CONCEPTUAL DESIGN REVIEW

MODIFICATIONS TO ECCS

SAN ONOFRE NUCLEAR GENERATING STATION, UNIT 1 (SONGS-1)

FIGURE 1
AS BUILT SYSTEM

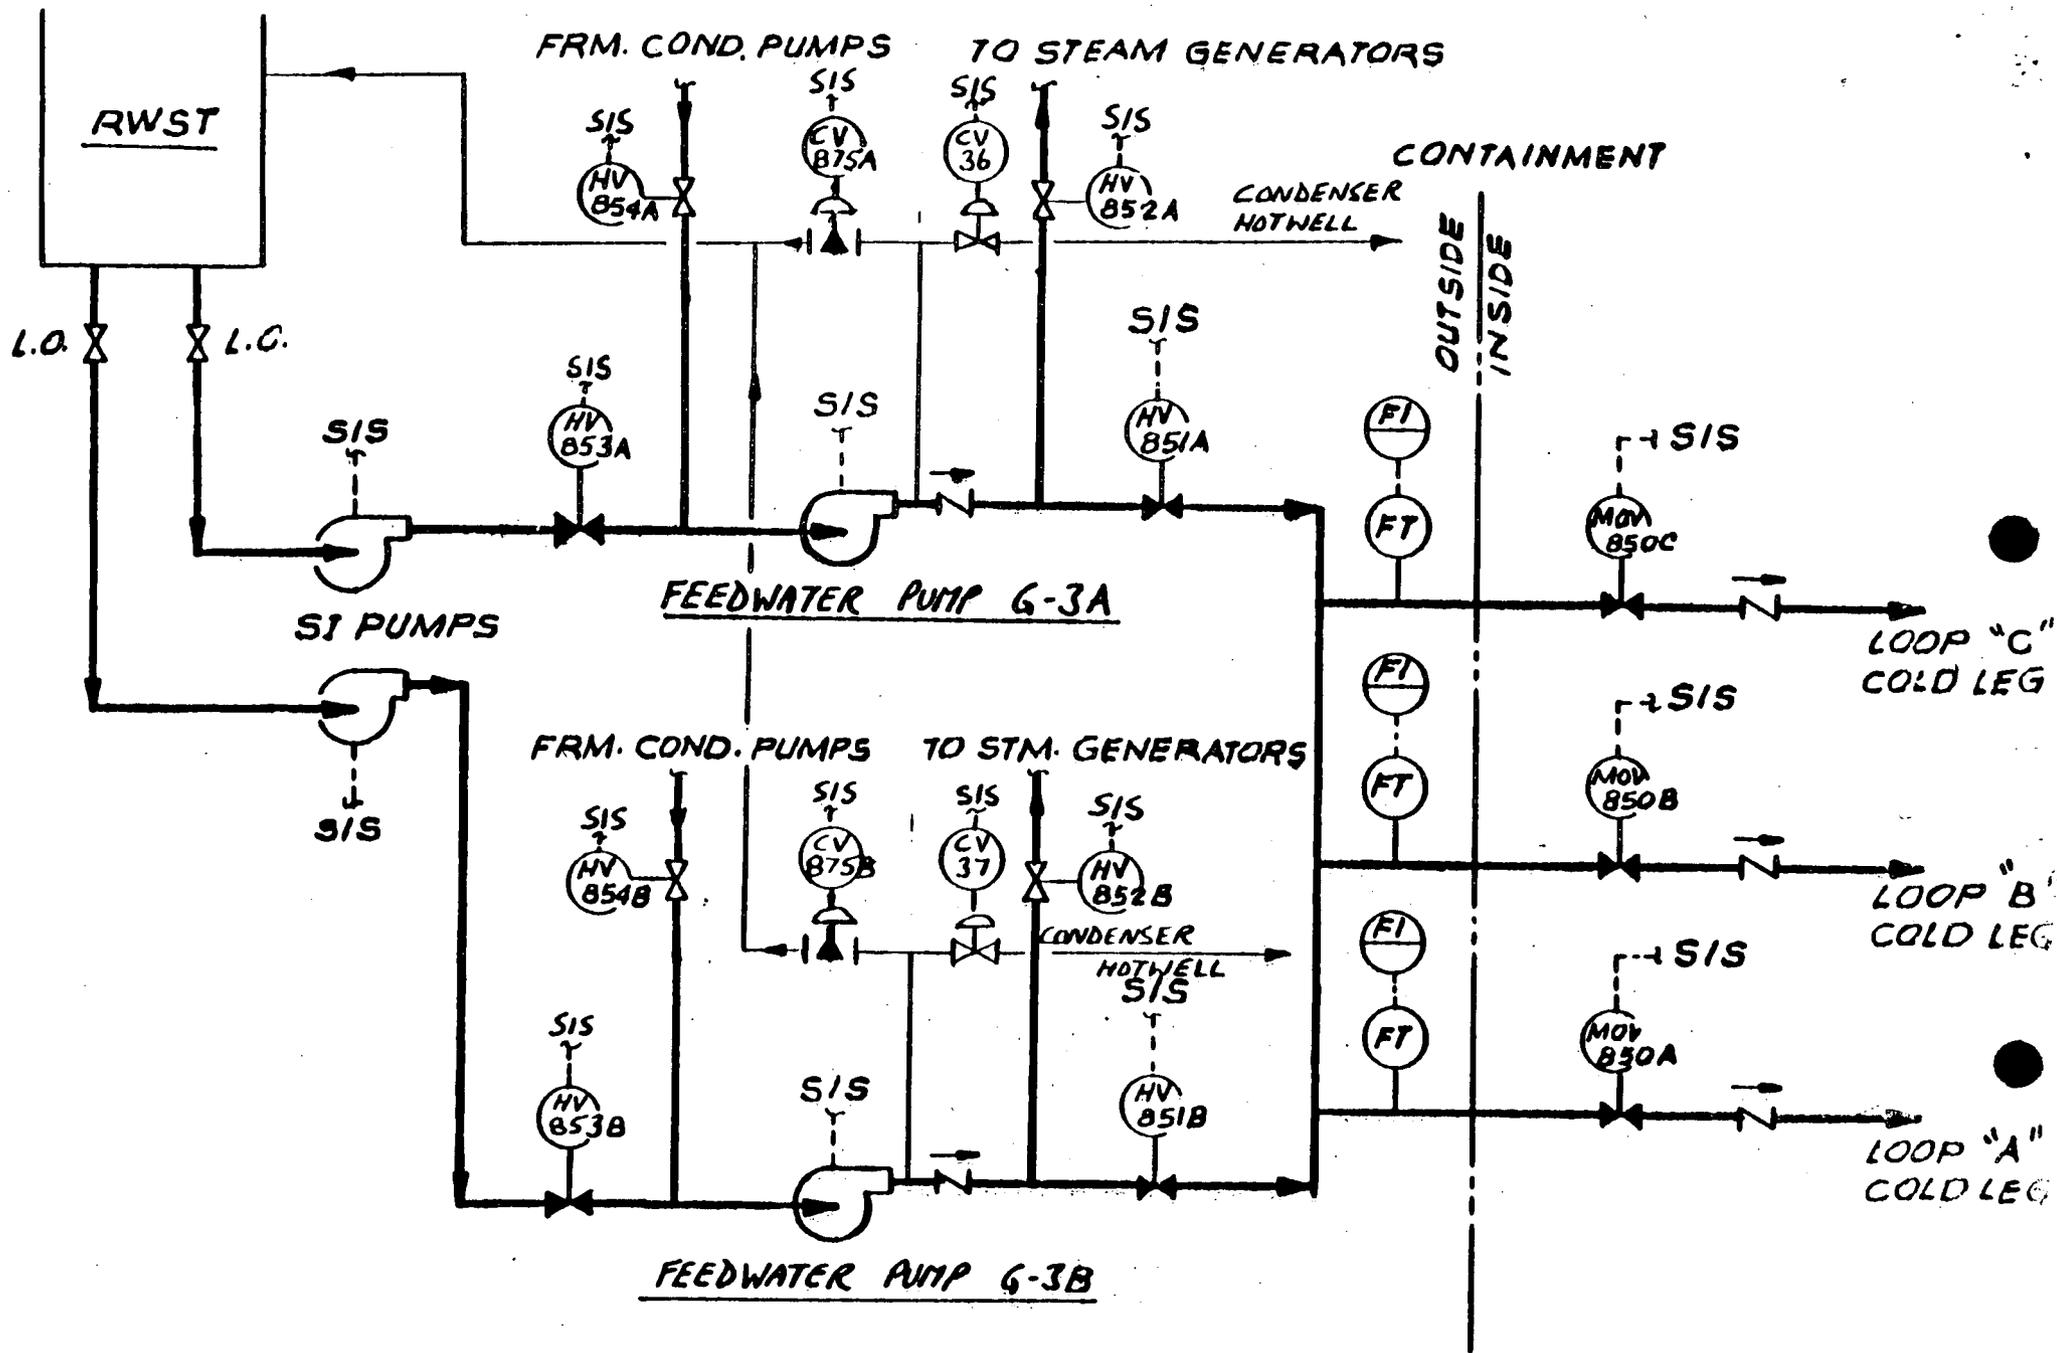
The feedwater pumps at San Onofre Unit 1 currently have dual functions. They are used to supply feedwater to steam generators during normal operation and inject borated water to the reactor for emergency core cooling when needed. Figure 1 presents the schematic flow diagram of the as-built system. The switchover from the feedwater function to safety injection function relies on the realignment of the safety injection system valves (HV 851 A & B, HV 852 A & B, HV 853 A & B and HV 854 A & B) located upstream and downstream of the feedwater pumps.

Following the event investigation, the licensee concluded that the combined feedwater/safety injection system design was a contributing factor to the common mode failure. Failure of the HV-851 A&B valves was attributed to one or more of the following:

- (1) Double-disk dragging - made possible by the double-disk gate valve design.
- (2) Undersized Actuators - the valve actuators were changed from motor-operated to hydraulically - operated in 1977 in order to reduce the stroke time.
- (3) Galling (metal to metal transfer between the disc and the valve seat) although galling was not evident after the September 3, 1981 event, subsequent testing of the valves showed clear signs of galling.

FIGURE 2
 (NEW DEDICATED FEED PUMPS)

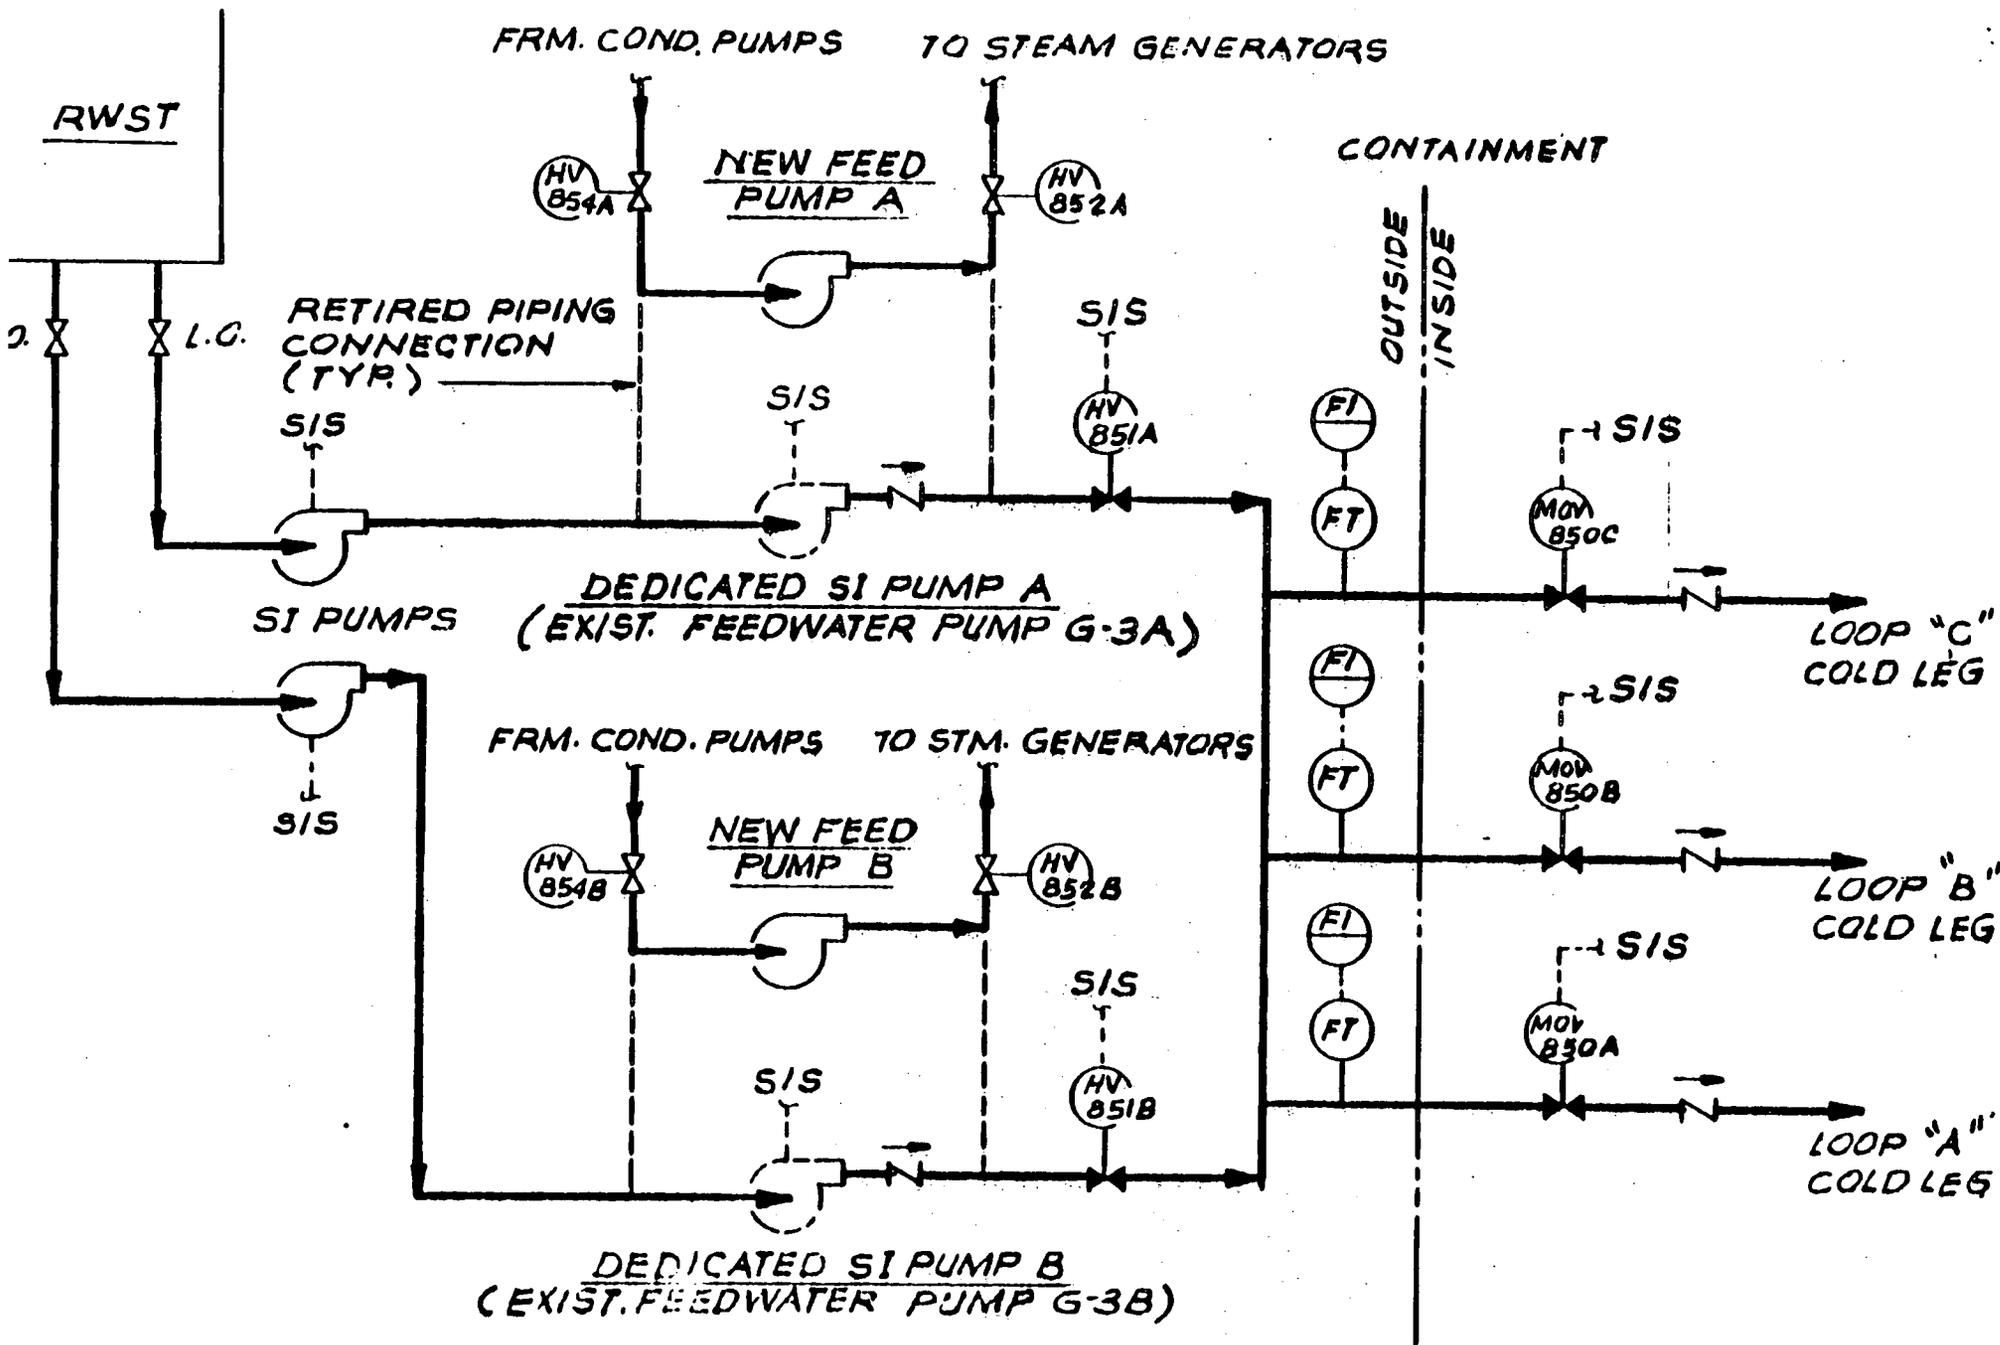
Figure 2 shows the proposed modifications to the existing piping and the new feedwater pump arrangement. Additional piping, isolation valves and check valves for the new feedwater pumps will be required.

The licensee has provided a conceptual design description of a revised SIS at San Onofre Unit 1. The objective of the SIS redesign is to minimize the reliance on extensive sequencing of the SIS hydraulic valves.

The staff agrees that a redesign of the SIS is warranted. The conceptual design information provided by the licensee is acceptable to the staff. However, the information provided to date is preliminary and design details have yet to be submitted. Before final staff approval is given to the SIS redesign, the licensee must submit a detailed description of the proposed modifications. In addition the licensee must submit a long term surveillance program for the SIS valves.
